CITY OF PORTLAND, OREGON

Staff Presentation to the  
**Portland Design Commission**

LU 16-104926 DZM AD

**1133 SW Market St**

### 33.266.130 (Table 266-4) Drive Aisle Width

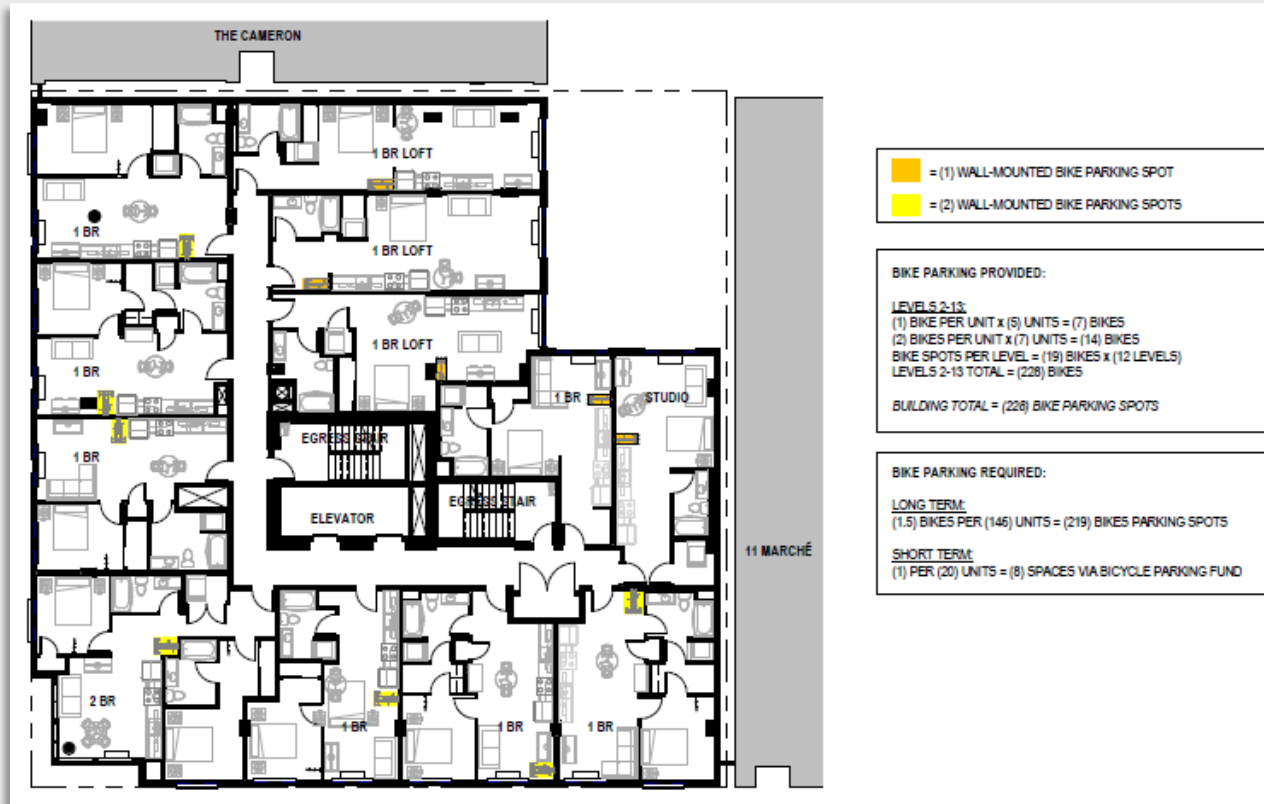
Required: 20' | Proposed: 18'

### STAFF SUPPORTS

**33.266.220 Bike Parking Stall Dimensions**  
 Required: 2'x6', 5' clear | Proposed: varies.

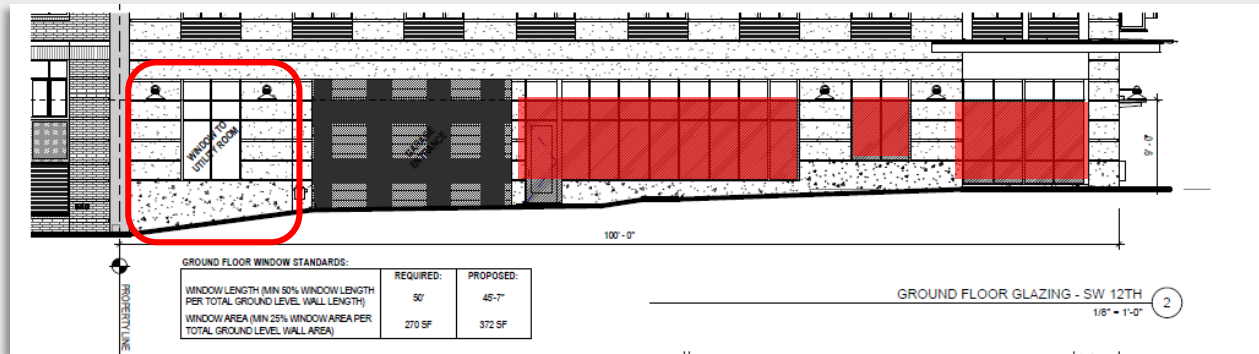
## STAFF SUPPORTS

### 33.130.230 Ground Floor Windows

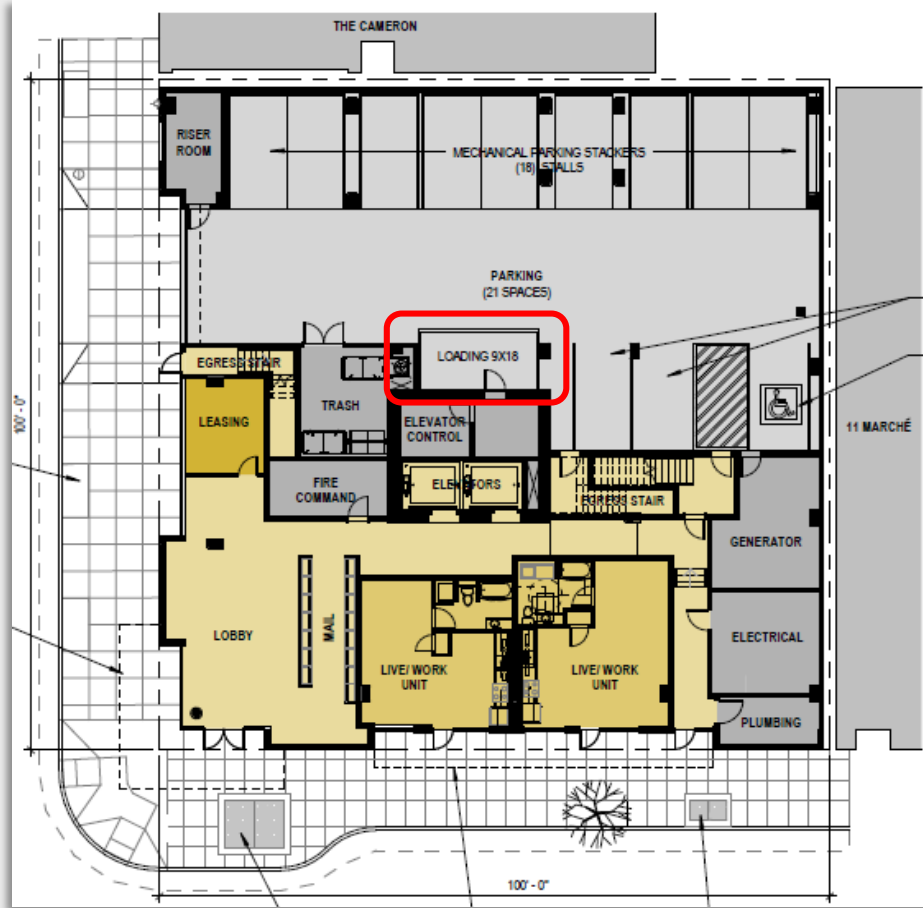
Required: 50% length, 25% area | Proposed: 45.5% length (4.5' short).

**STAFF DOES NOT SUPPORT** – No mitigation offered.

### **33.510.263.G.9. Ground Level Parking in the West End**

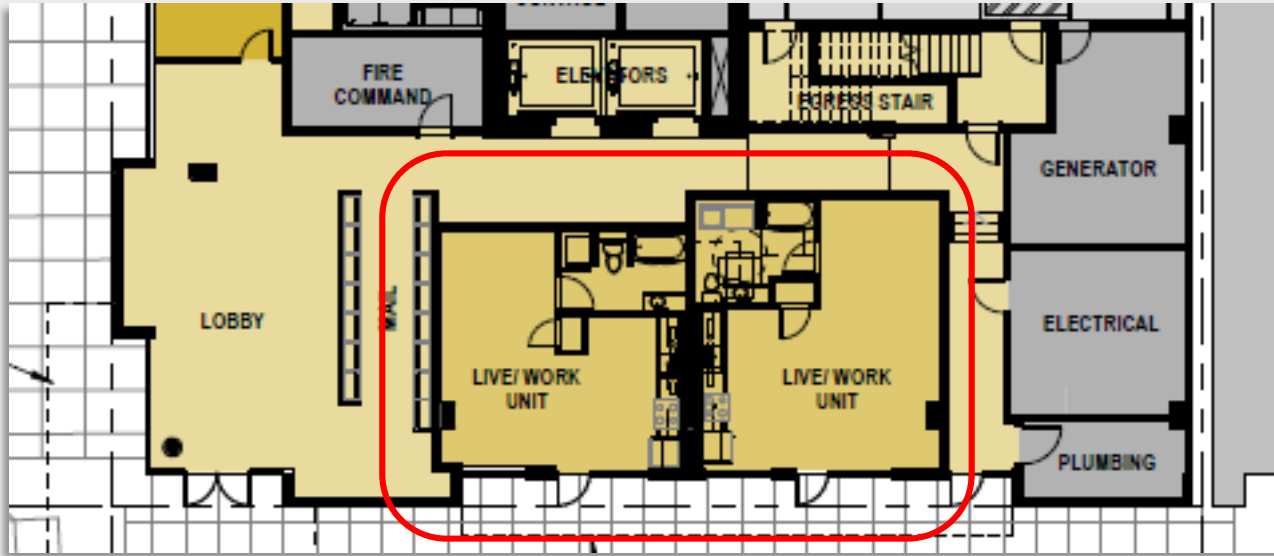
*Required: 1 space/5,000SF site area | Proposed: 21 spaces*

## STAFF SUPPORTS

Balconies

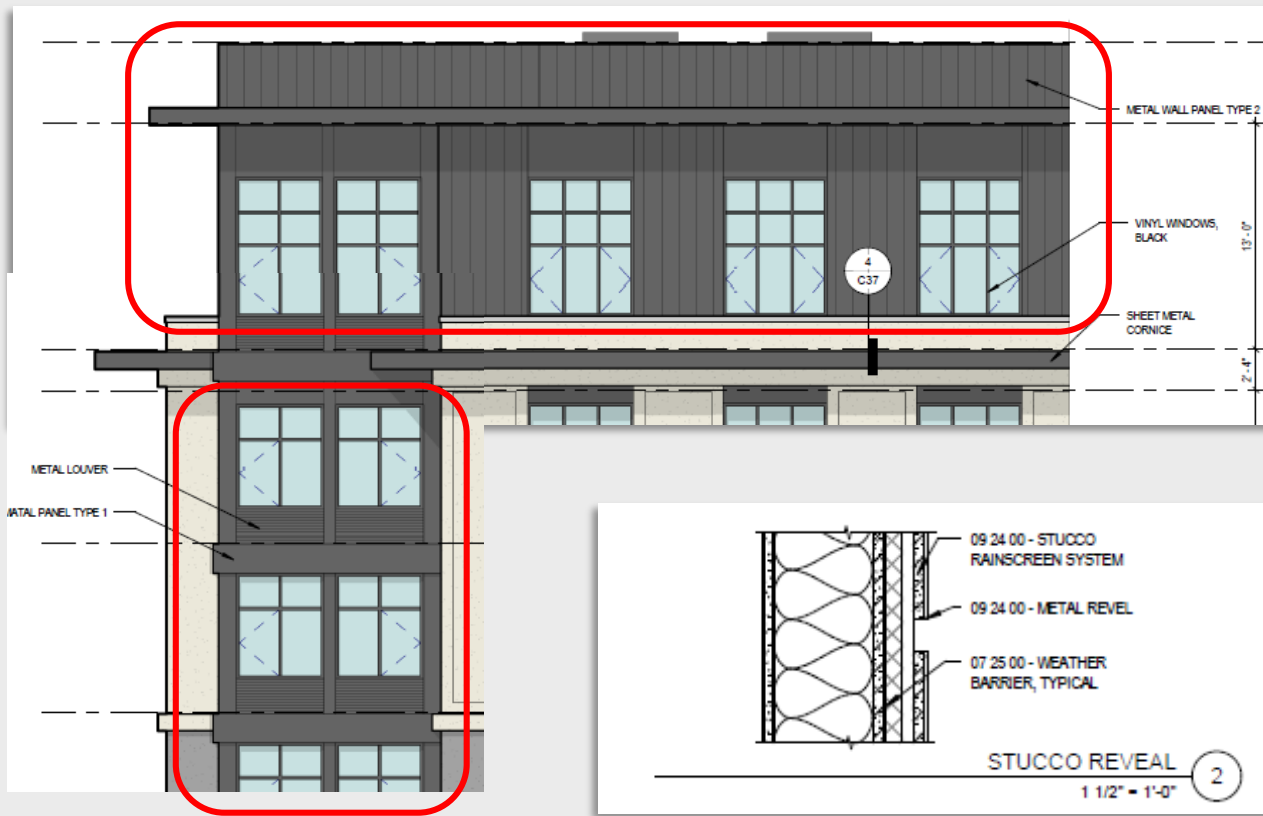
*The proposal includes no balconies within an area rich with view opportunities and older buildings with ample balconies.*

**Guideline Not Met:** *C1 Enhance View Opportunities.*
